RE : Application for Official Plan Amendment & Zoning By-Law Amendment
 Place Lux (6770967 Canada Inc.)

Project : 1178 Cummings Ave. & 1098 Ogilvie Rd. (D01-01-19-0012/D02-02-19-0078)
N/D : 1712

This addendum letter has been prepared to address City of Ottawa comments received on March 24th, 2020 related to the Application for Official Plan Amendment & Zoning By-Law Amendment dated July 11th 2019 and deem completed January 14th, 2020. City comments are noted in black text, with the corresponding responses from Parsons provided in blue text.

ADDENDUM LETTER _ APPENDIX A

SUBJECT LAND CONTEXT MAP SHOWING ST-LAURENT AND CYRVILLE TOD'S MAXIMUM HEIGHT AND MINIMUM DENSITY

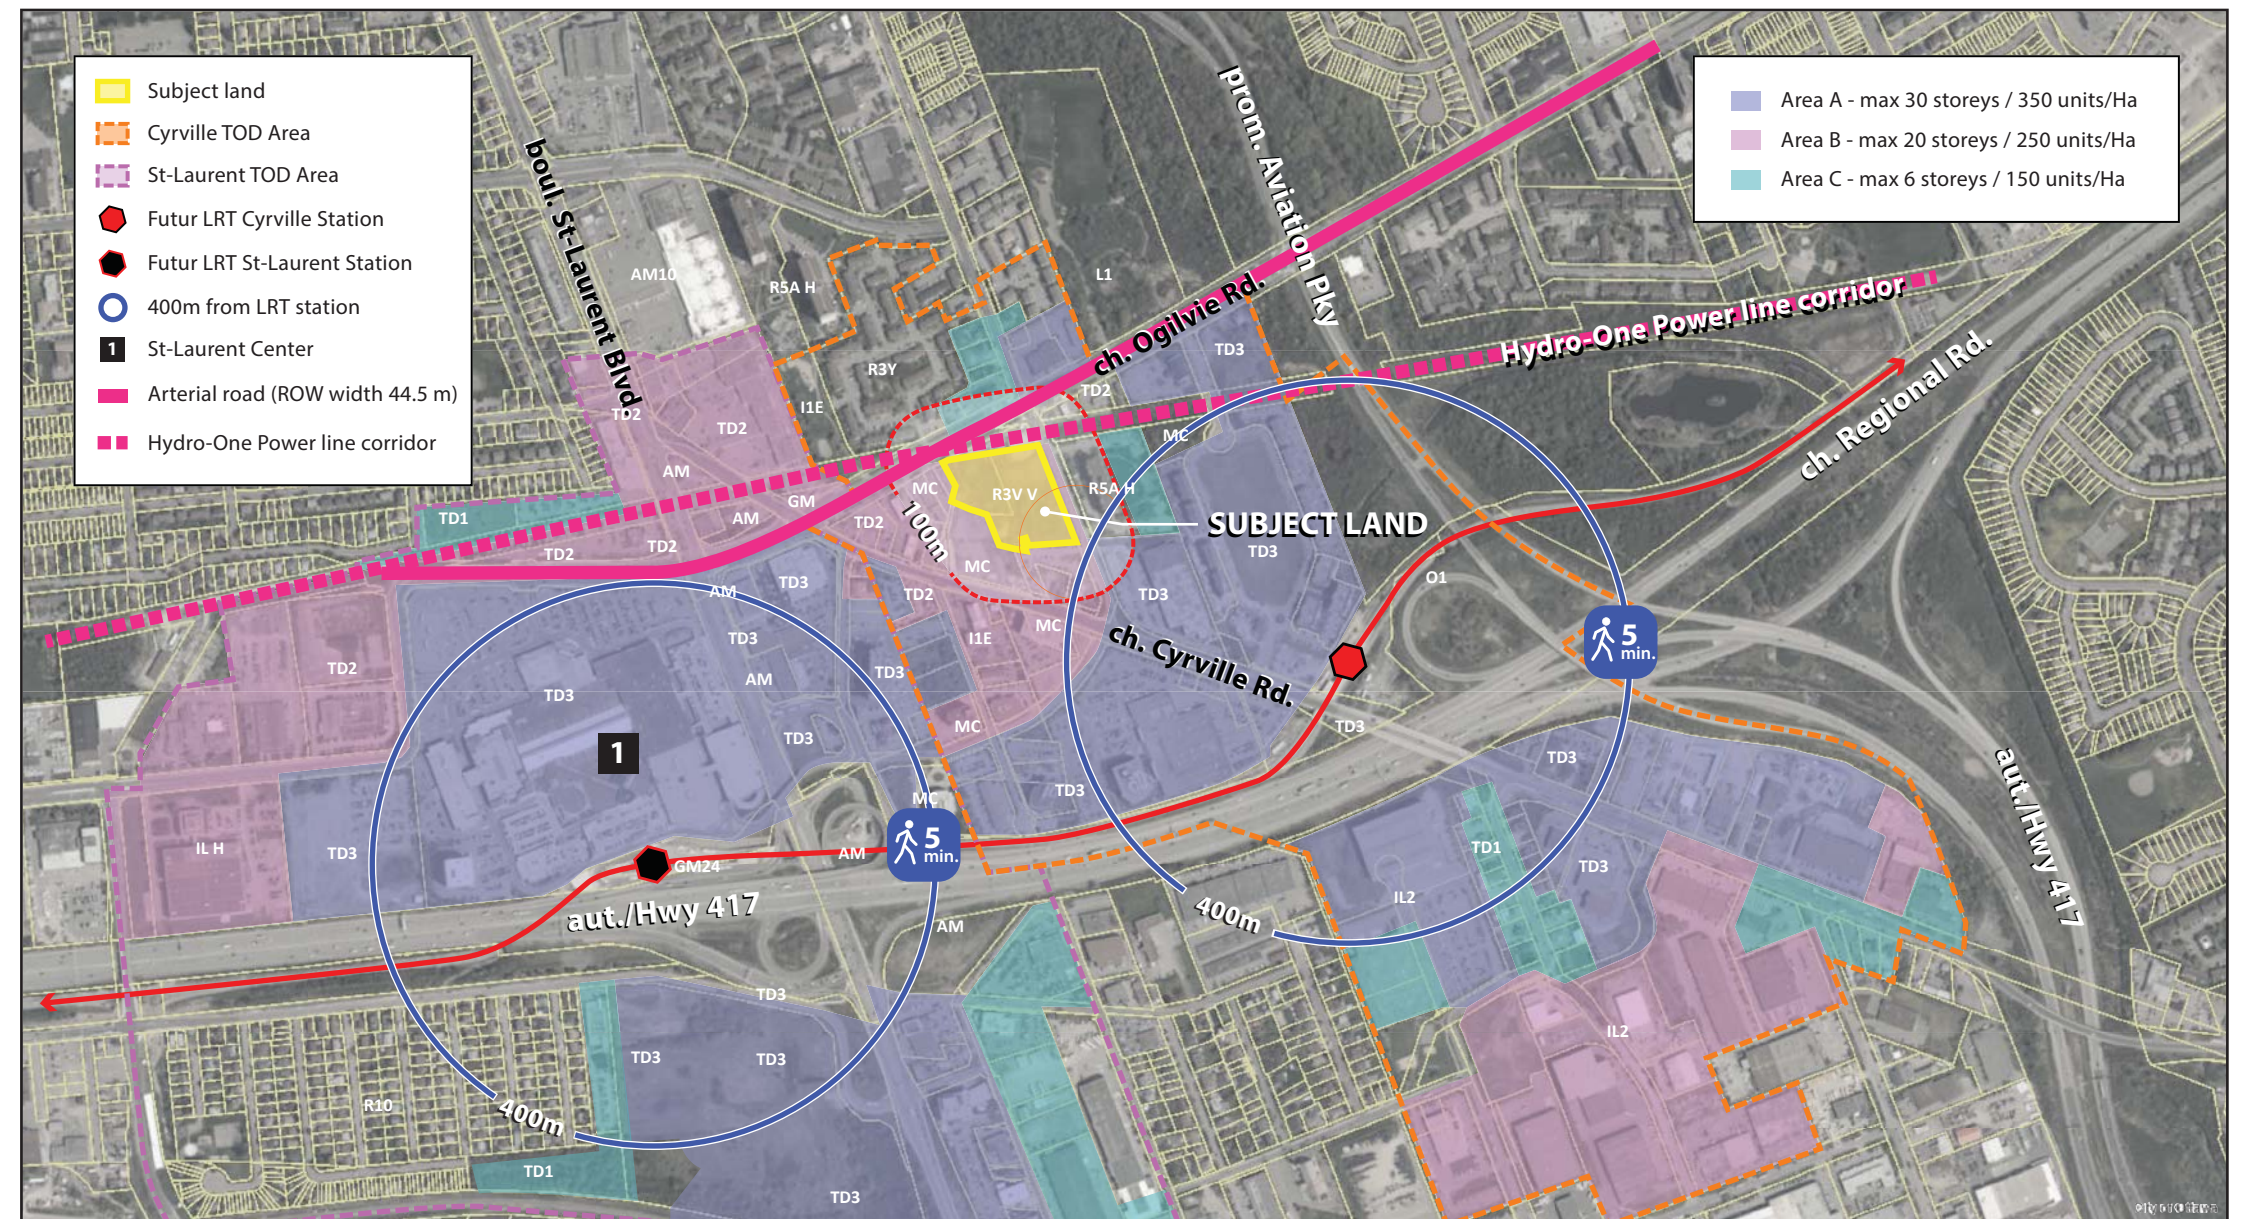
Merging Schedule B St-Laurent TOD and Schedule C Cyrville TOD of the Tremblay, St-Laurent and Cyrville Secondary Plan reveals that properties further away than the measured of 400 metres walking distance or from a radius equal to ¾ walking distance from the centre point of the St-Laurent and Cyrville O-Train Station (policy 2.2.2.21) have a TD3 subzone zoning. It also

reveals that the triangle in which the subject site is in a "pocket" between the St-Laurent TOD and the Cyrville TOD is designate as Area B with a maximum high of 20 storeys. This area is confined between a TD3 subzones from St-Laurent TOD to the west, by a TD3 subzones from St-Laurent TOD adjacent to the Highway 417 (Queensway) to the south by Cummings Avenue (arterial road with a ROW width of 37.5 metres) to the east and by the abutting Hydro One Networks' transmission corridor and Ogilvie Road (arterial road with a ROW width of 44.5 meters and Transit Priority corridor) to the north. These elements constituting the urban context of the proposed development create enough distances for a suitable transition, as required by section 4.11 policies 11 and 12, between the proposed High-rise buildings and existing and planned low-rise residential areas. It also makes it possible to reconcile all urban planning constraints and limit the negative impact linked to shading, to wind and to the supply of light in adjacent public spaces. Based on this contextual analysis made at a larger scale, we believe granting the subject site with a TD3 subzone zoning is appropriate and defensible from an urban design point of view. (Appendix A).

SUBJECT LAND CONTEXT MAP SHOWING NEW SUGGESTED ST-LAURENT AND CYRVILLE TOD'S MAXIMUM HEIGHT AND MINIMUM DENSITY PROVISION

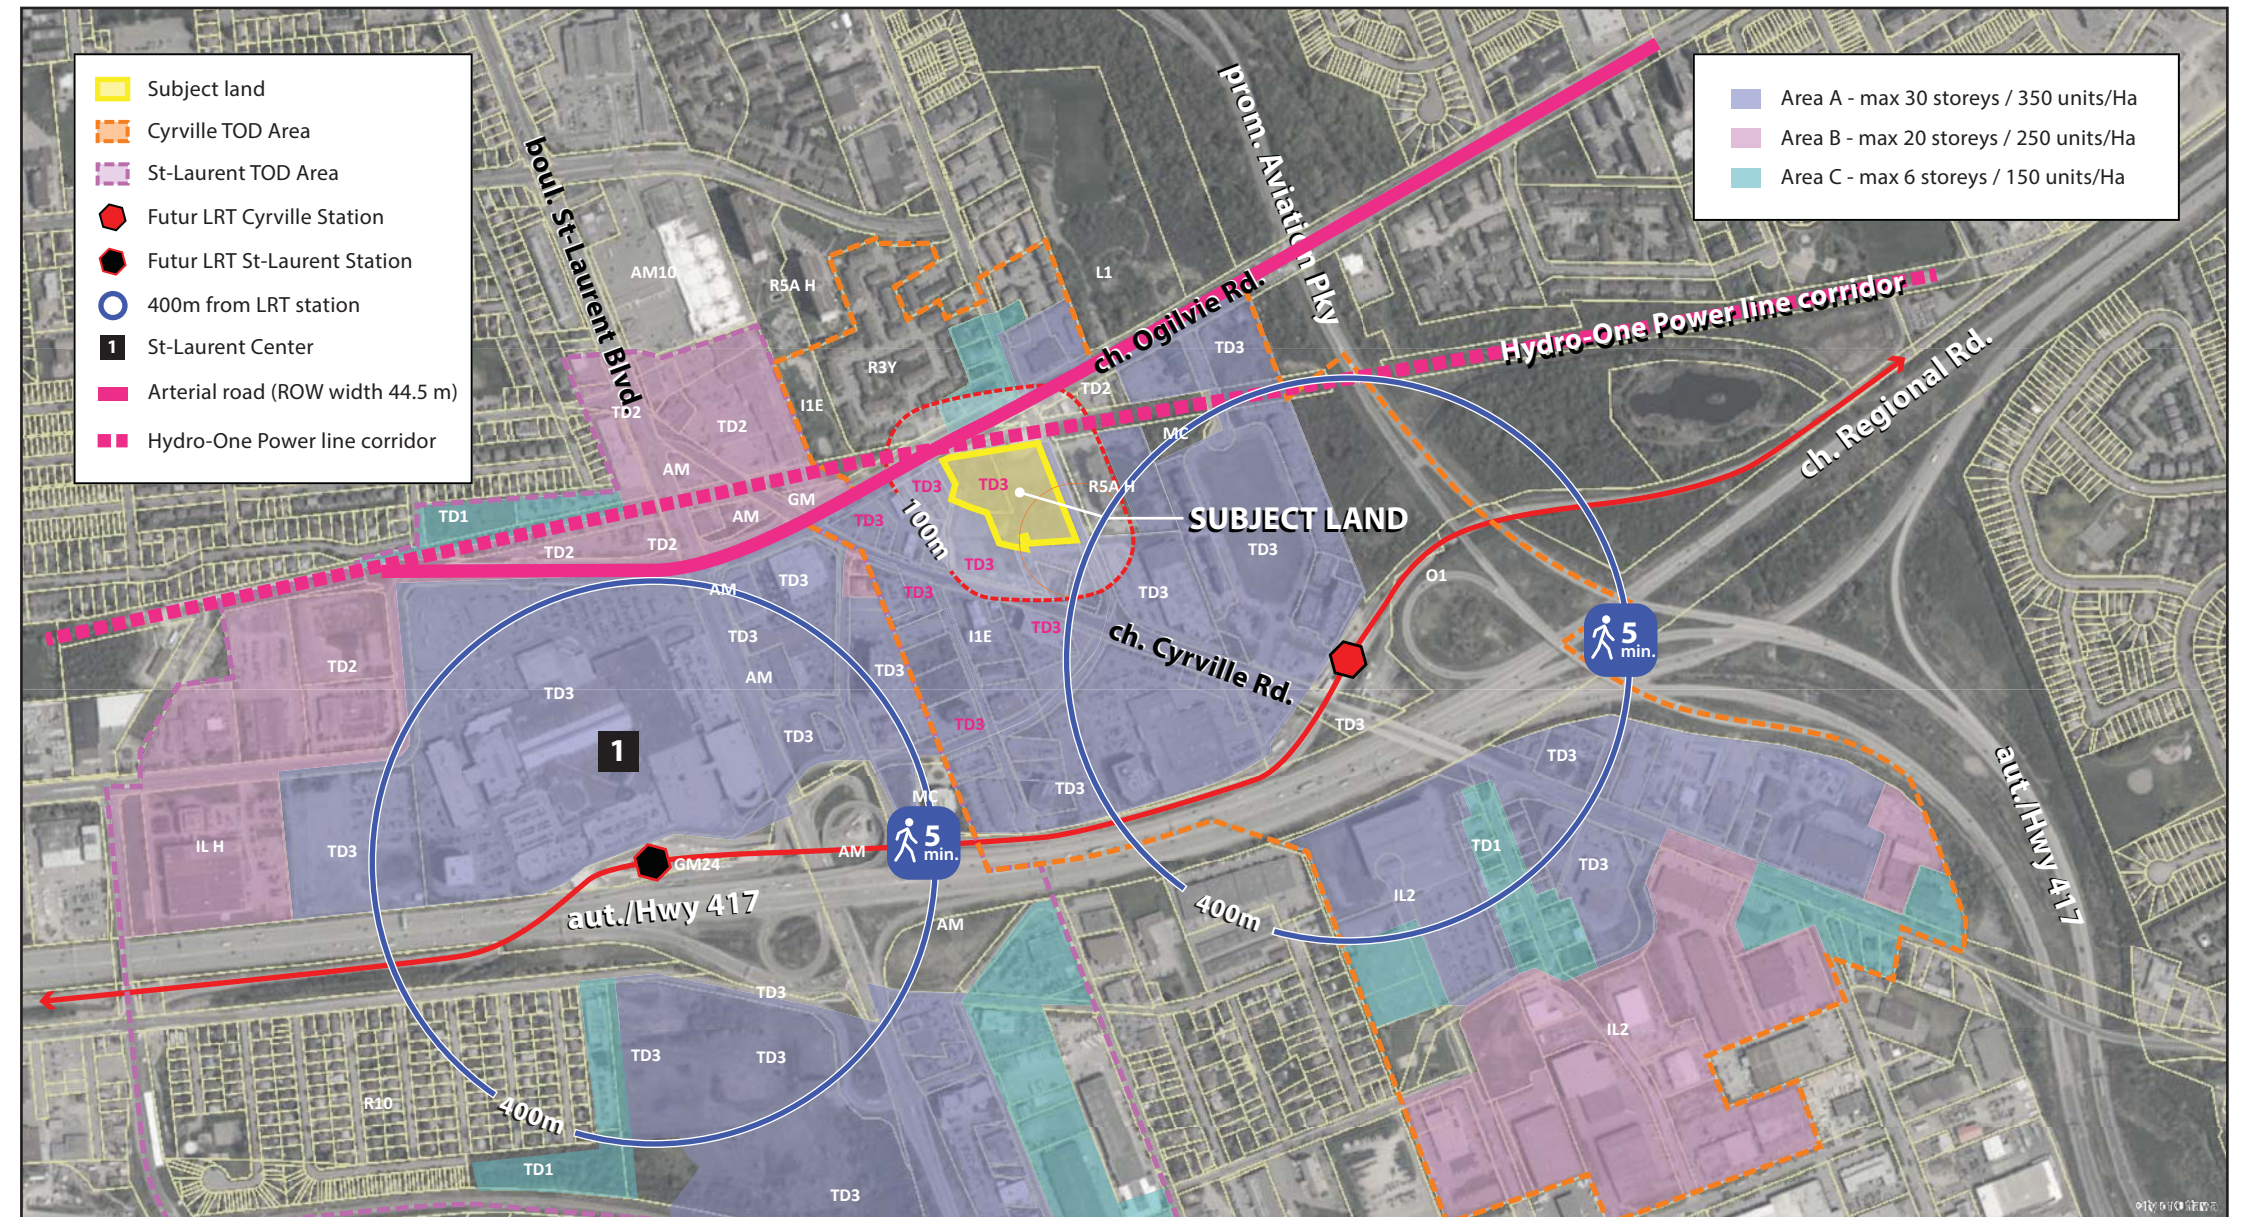
- a) a comprehensive assessment of the impacts of the proposed 30+ high-rise development on the surrounding area (e.g. the Secondary Plan area), outlined above.
- b) What would the area look like with the proposed building height and mass as compared to the current height regime established in the Secondary Plan? To help answer this question, a conceptual block plan, illustrations and 3D renderings of the area bounded by Ogilvie Road, Cummings Avenue and Cyrville Road should be submitted to illustrate the planned future

conditions established by the Secondary Plan as compared to the potential future conditions with the proposed 30+ high-rise development.

Noted. a) Please see response to these policy in point 1 above b) We produced a 3D model of the Cyrville and St-Laurent TOD area to illustrate the proposed building height and mass in a short-term. We also produce a conceptual block plan to illustrate the planned future conditions established by the Secondary Plan as compared to the potential future conditions with the proposed 30+ high-rise development. (Appendix A)

ADDENDUM LETTER _ APPENDIX B

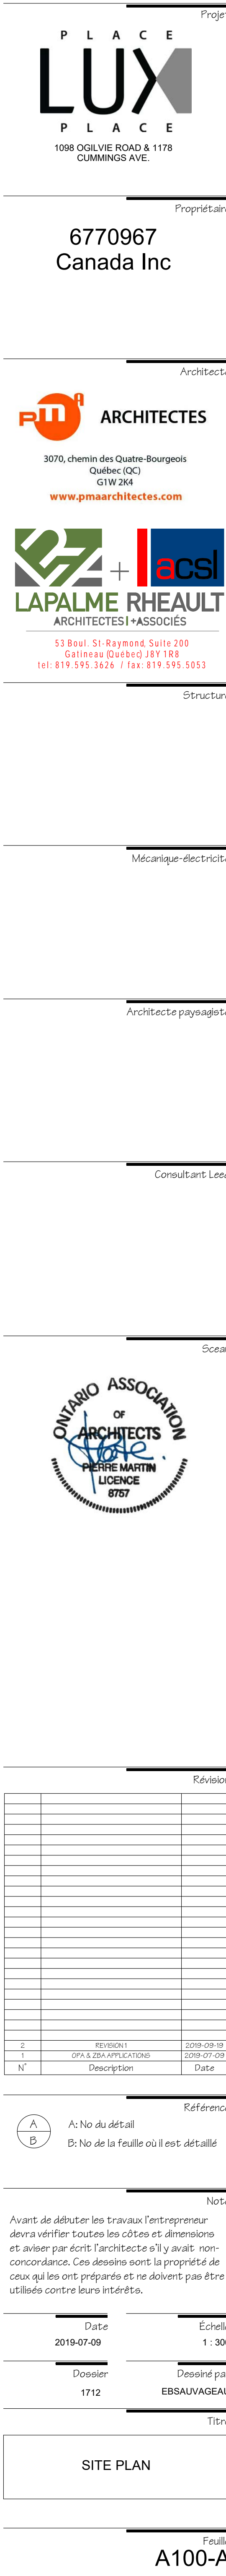
g) Amenity Area & Communal Amenity Area – I will require an accounting of the total amenity area and communal amenity area on the site in accordance with Section 137 and Table 137(5) and Section 195(8) of the Zoning By-law. Please provide your summary on a revised site plan in tabular format.

[Noted. A summary on a revised site plan has been produced \(Appendix B\)](#)
